Technical Advisory Committee

Meeting Minutes

May 4, 2023

GM Development's request for approval of a Development Plan for a Police Station at 7520 Civic Drive

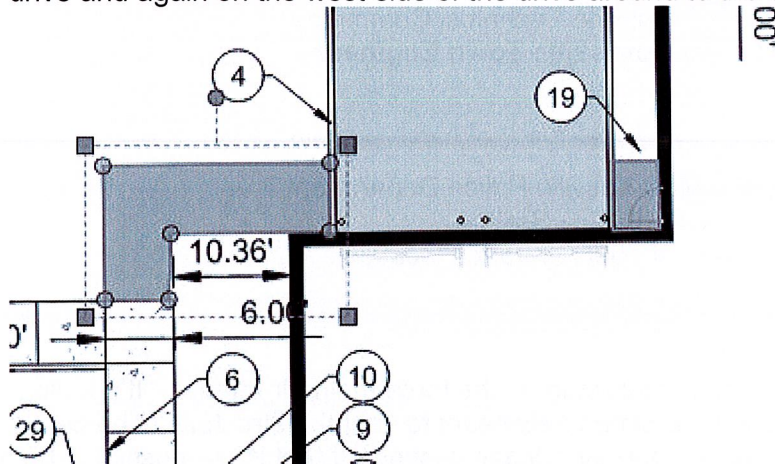
1. On the site plan, note 16, that structure is the force main air release. It should not be within pavement in case it becomes necessary to vent the structure. The path should be aligned between the hydrant and air release casting. If that is not possible, the hydrant should be shifted towards 750N.
